From: John.Conly@luminant.com
Sent: Wednesday, April 29, 2009 8:12 AM
To: Monarque, Stephen; Willingham, Michael
Cc: Donald.Woodlan@luminant.com
Subject: Update Tracking Report
Attachments: ER_UpdateTrackingReport_Rev2.pdf; FSAR_UpdateTrackingReport_Rev1.pdf

**Comanche Peak Nuclear Power Plant, Units 3 & 4
COL Application**

**Part 3,
Environmental Report
Update Tracking Report**

Revision 2

Figure 4.4-1 CPNPP Total Project Staffing

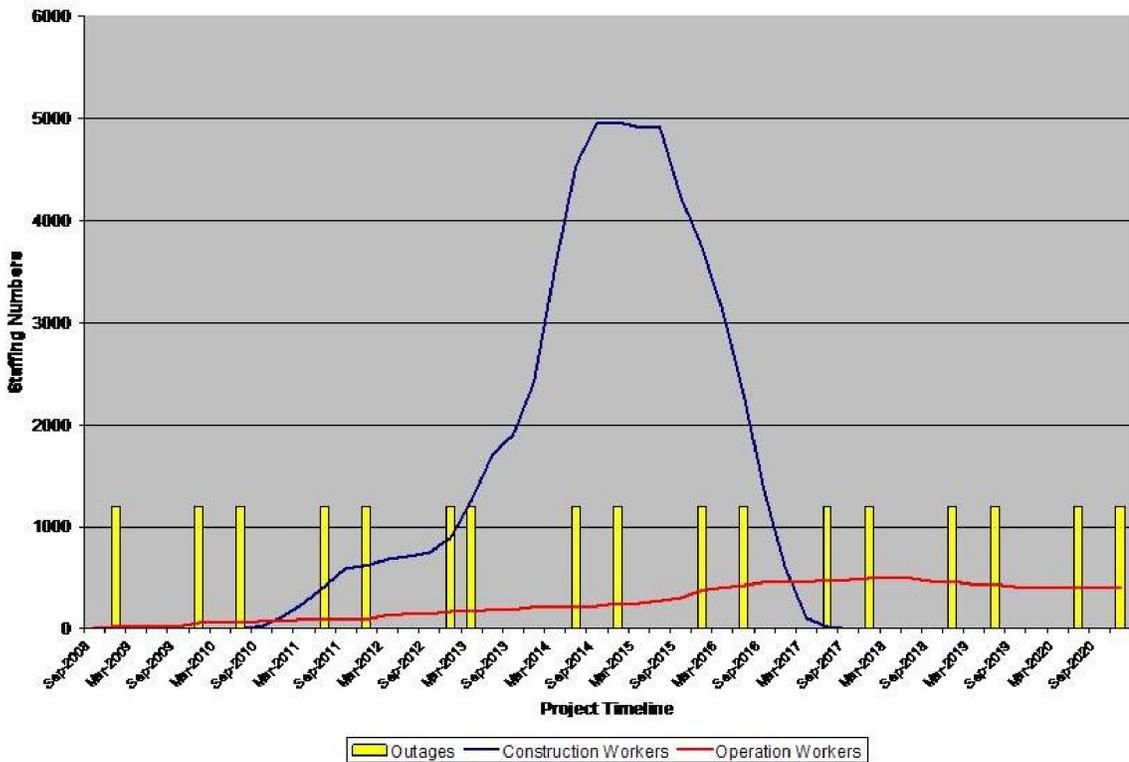
SOC-03	Figure 4.4-1		Increase information as discussed with the NRC	Added table to show total project staffing.	2

During peak construction, approximately ~~in the year 2015~~ towards the end of 2014, there are expected to be ~~4300~~ 4953 construction workers on-site in addition to 248 operations workers as shown on Figure 4.4-1. Some of the different trade skills represented in the labor pool include electrical workers, welders, pipe fitters, etc. To ensure that the necessary labor pool is available, as the demand for workers increases, construction companies recruit employees from local technical school programs and work with school administrators to build up curriculum in the necessary labor trade areas. National labor trade union organizers, such as the American Federation of Labor, have made it a high priority to train new entrants in the construction industry as the need for labor ramps up. In addition, local recruiting of craft personnel, supplemental skills training, attractive compensation packages, and use of specialty contractors are expected to mitigate competition for craft workers between industries.

Figure 2.2-201 Transportation Routes, Storage Tank Locations, and Industrial Facilities within 5 mi of CPNPP

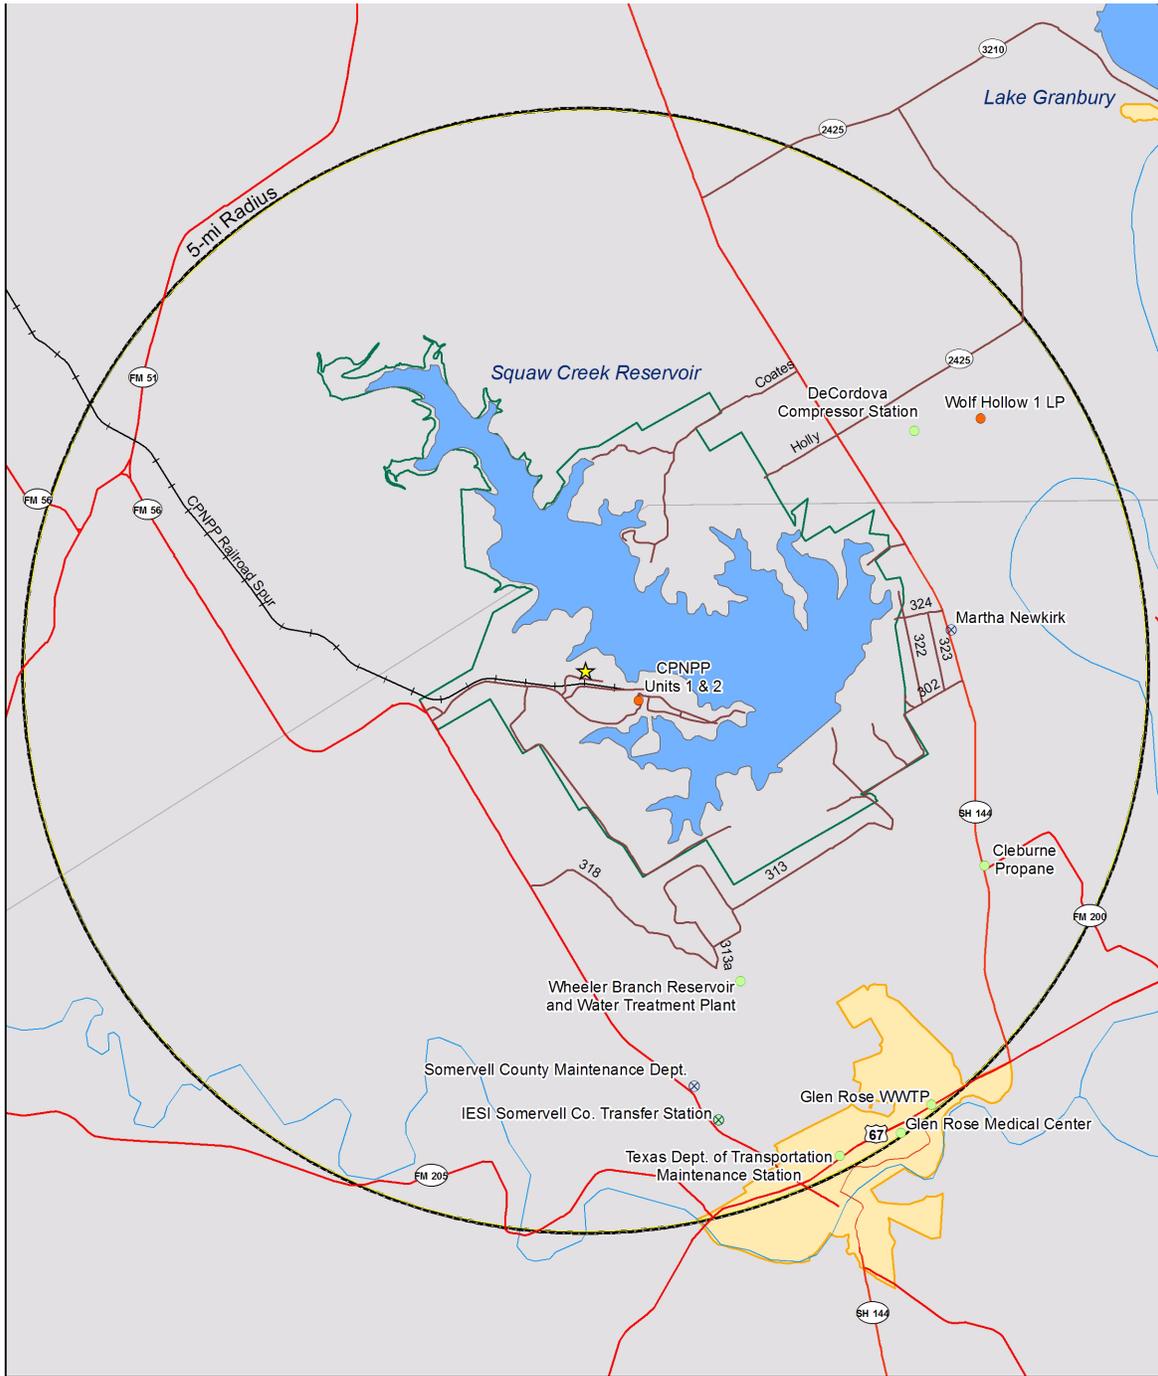
CTS-00696	Figure 2.2-201		Erratum	Corrected the figure since the location of DeCordova, which is outside the 5 mile radius of CPNPP Units 3 & 4, showed DeCordova inside the 5 mile radius	1
MET-03	2.3.1.2.4	2.3-14	Increase information as discussed with the NRC.	Add "16" to number of days each year; remove "monthly and regional" and add "by county" to wind events to reconcile thunderstorm information.	1
MET-04	2.3.1.2.8	2.3-20	Erratum	Add "the" in front of Dallas Fort Worth Airport	1
MET-13	2.3.2.1.2	2.3-22	Erratum	Replace "2001 through 2006" with "2001 – 2004 and 2006" to describe which data years were used.	1
MET-13	2.3..2.1.3	2.3-27	Erratum	Replace "2001- 2006" with "2001 – 2004 and 2006" to	1
